UNITED STATES PATENT AND TRADEMARK OFFICE

10/606,848

Brian Phelps

Office Action Summary

FIG. 2
(PRIOR ART)

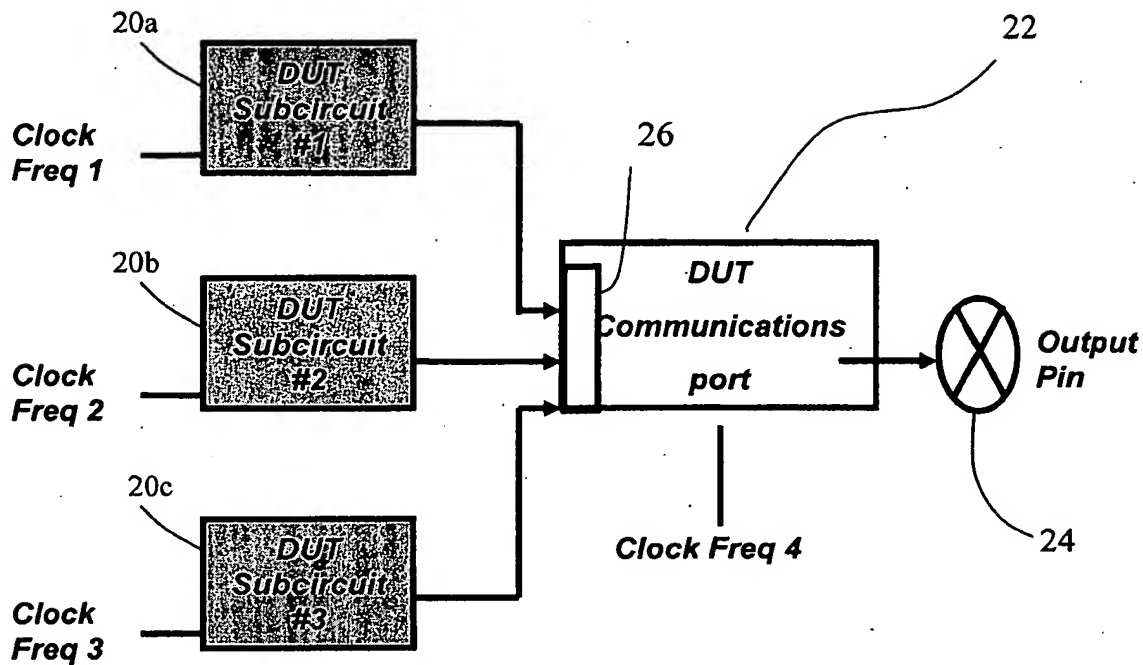
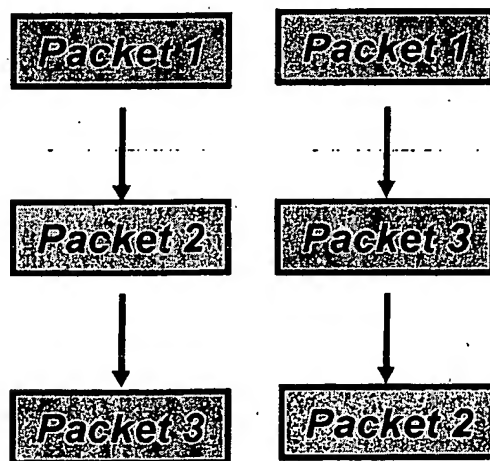
The attached sheet(s) of drawings includes changes to Figures 2 and 3.
